Architect's Supplemental Instructions

Wilma P Mankiller Expansion
Stilwell, OK

ASI Number: Bid Package 02 ASI 07

Construction Documents – ASI 07 – Wilma P. Mankiller Health Center Expansion

SHEET NUMBER:
CG500

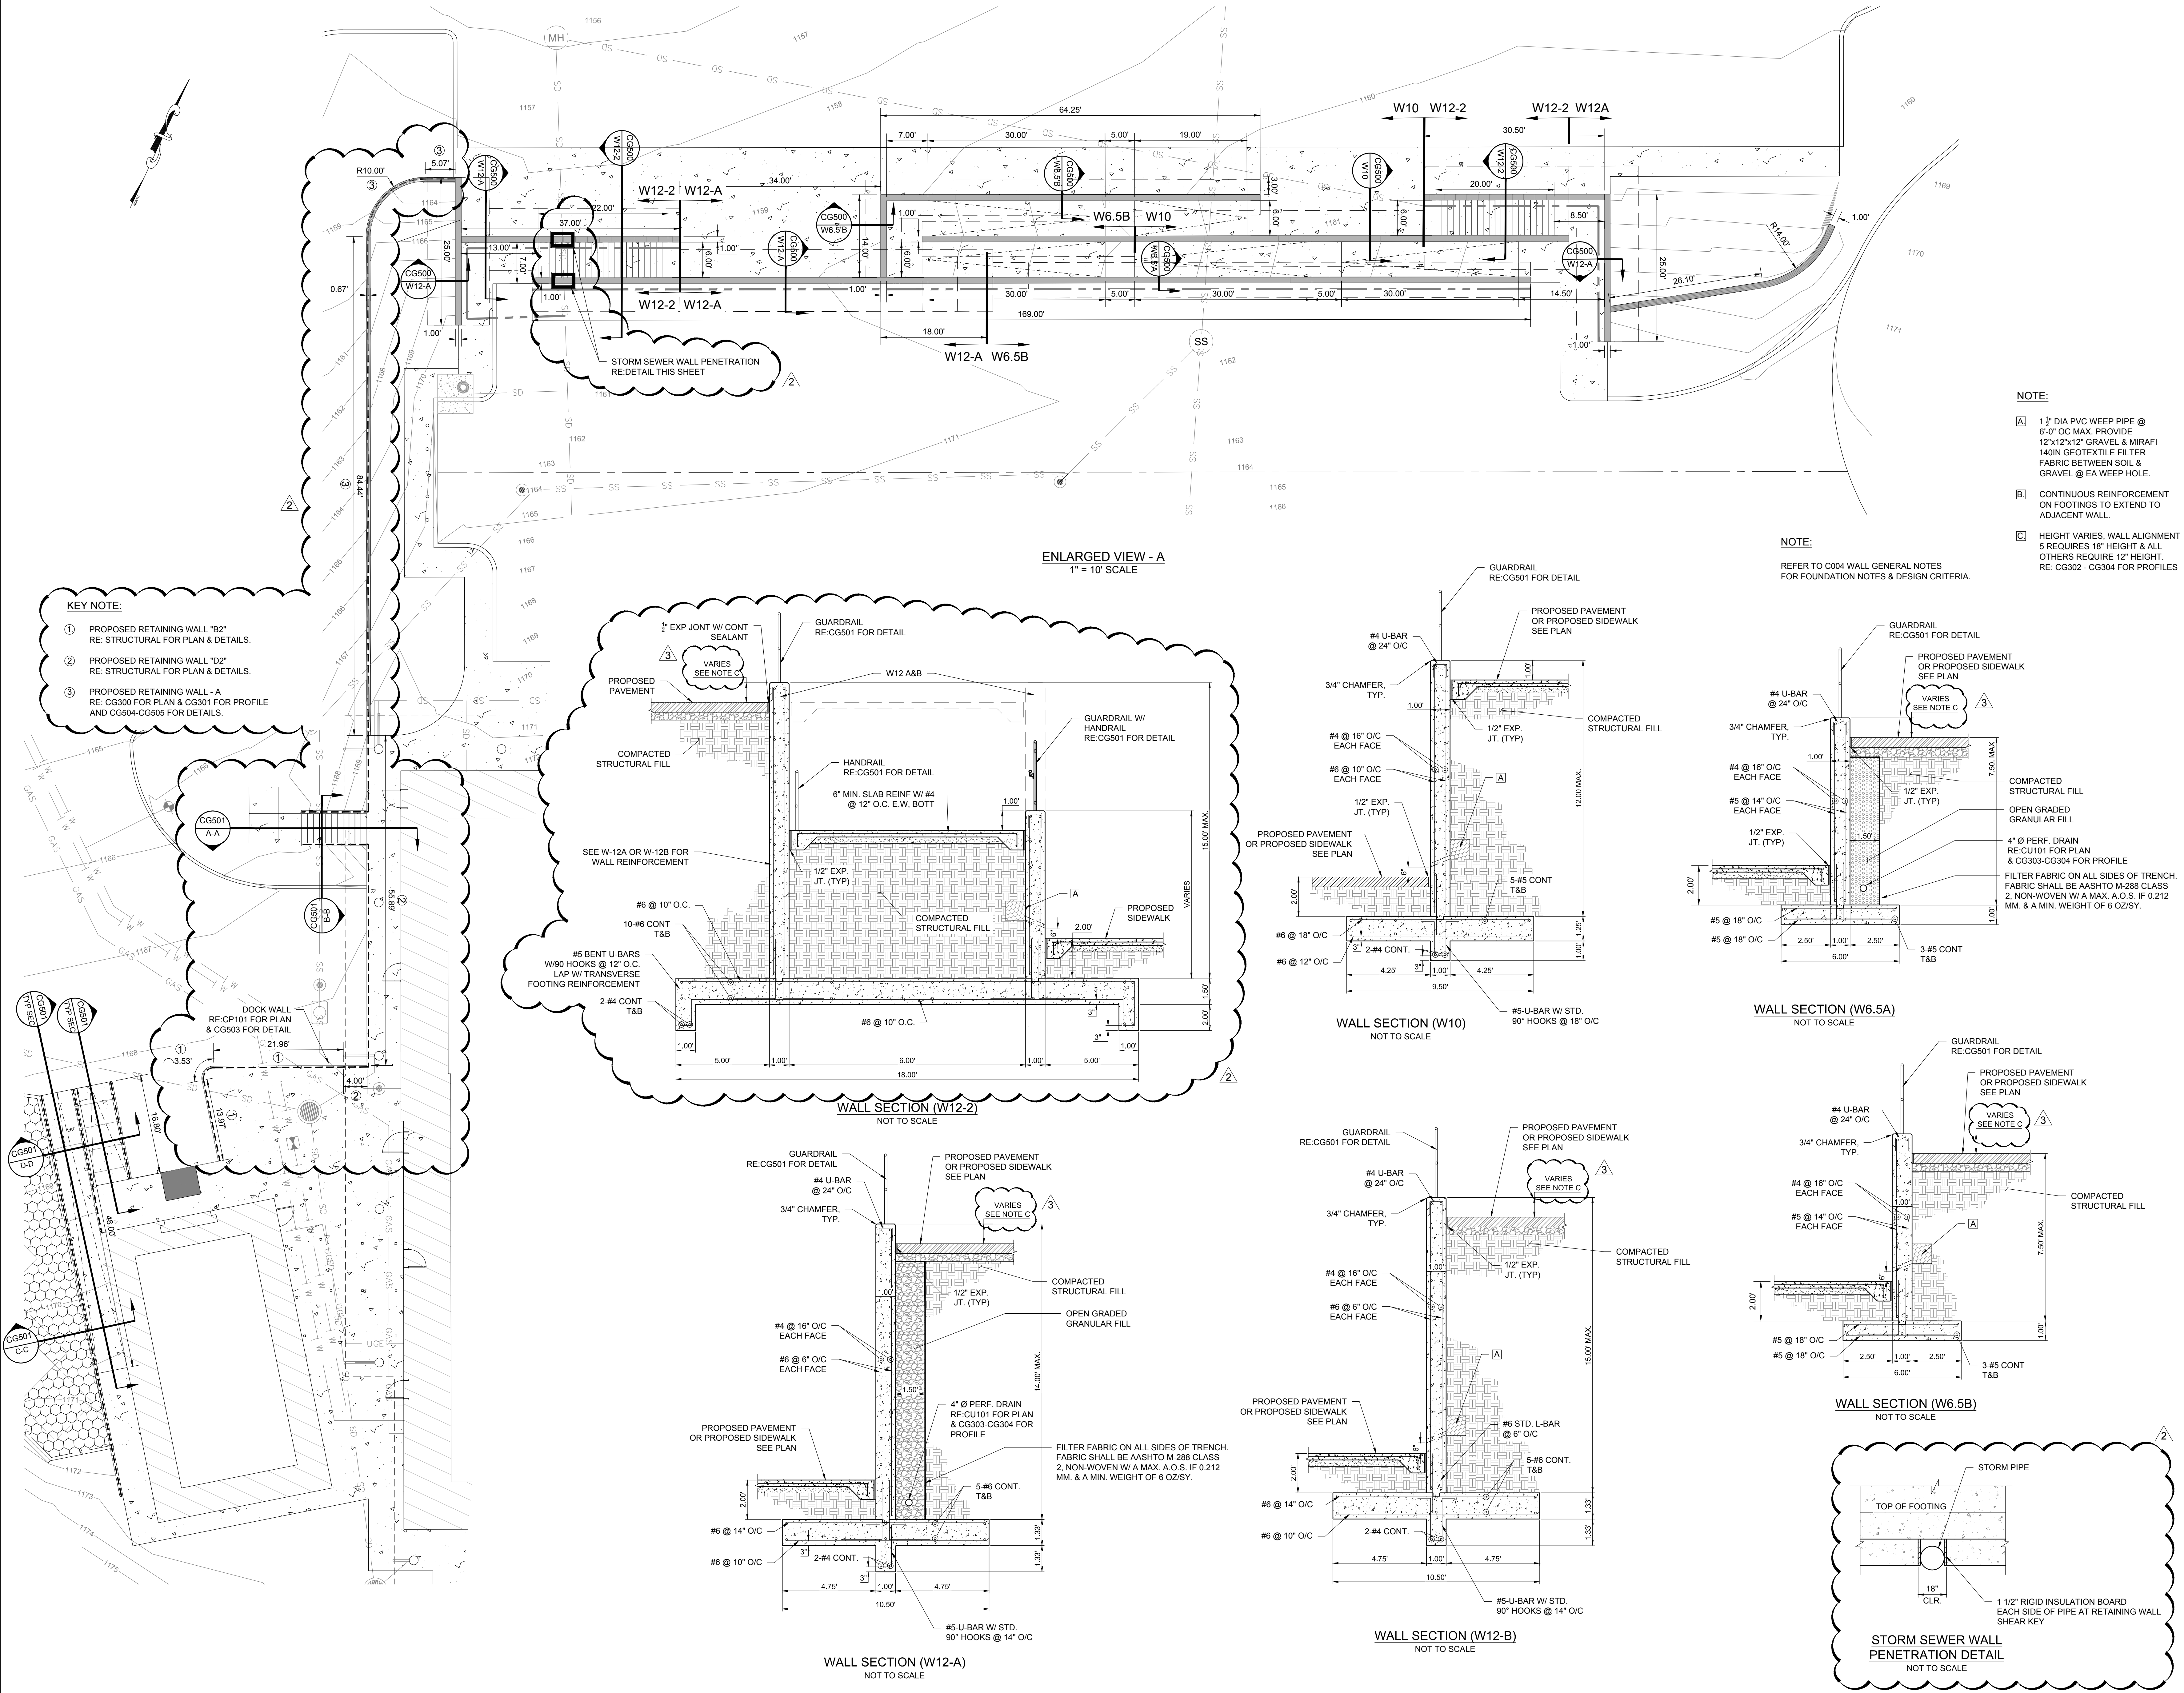
CG500

1. Modified wall details to show that wall nearest to the parking lot has 18 " height and all others still have 12"

- NOTE:**
- A 1 1/2" DIA PVC WEEP PIPE @ 6'-0" OC MAX. PROVIDE 12"x12"x12" GRAVEL & MIRAFI 140IN GEOTEXTILE FILTER FABRIC BETWEEN SOIL & GRAVEL @ EA WEEP HOLE.
 - B CONTINUOUS REINFORCEMENT ON FOOTINGS TO EXTEND TO ADJACENT WALL.
 - C HEIGHT VARIES. WALL ALIGNMENT 5 REQUIRES 18" HEIGHT & ALL OTHERS REQUIRE 12" HEIGHT. RE: CG302 - CG304 FOR PROFILES.
- NOTE:**
REFER TO C004 WALL GENERAL NOTES FOR FOUNDATION NOTES & DESIGN CRITERIA.
